FSN Ref: 448955 FSCA Ref: 448955

# **Urgent Field Safety Notice**

# IPPB Flextube<sup>TM</sup> breathing system

Figure 1: IPPB Breathing system schematic showing zoom detail of nebuliser and supply line T-Piece connection

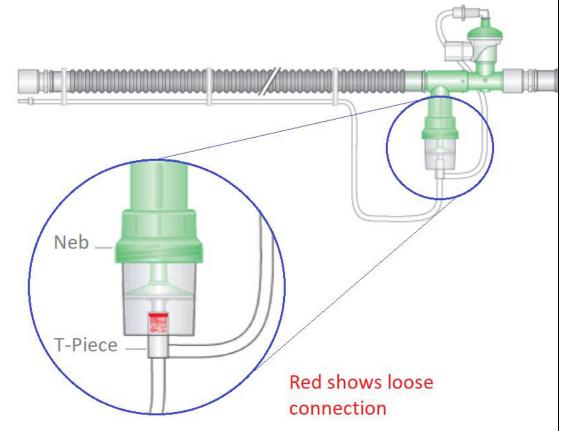
1. We have received a report of loose connections between the nebuliser and supply line T-Piece in one of our IPPB breathing systems (see figure 1 below). When the system is pressurised, there is the possibility that the T-Piece can detach from the nebuliser.

2. As a result of the reported problem, we have identified the opportunity to improve the current Instruction For Use provided with these products. The Pre-Use Checks section will in future include the following warning;

"WARNING: Every component of the breathing system must be visually inspected and checked for function, leakage and occlusions, immediately before use on each patient. Ensure that connections are secure using a push and twist action."

2. The security of connection between the Nebuliser and T-Piece can be checked by hand through the packaging. Secure connection should be possible using the push and twist action as detailed in the device Instructions For Use.

Additionally to the current instructions for use, you must confirm a secure connection can be achieved between the nebuliser and gas supply, using a push and twist action. This new instruction is currently being added to the IFU for the future.

2. If a secure connection cannot be achieved with a device, remove from use, quarantine the product and please return to us immediately.
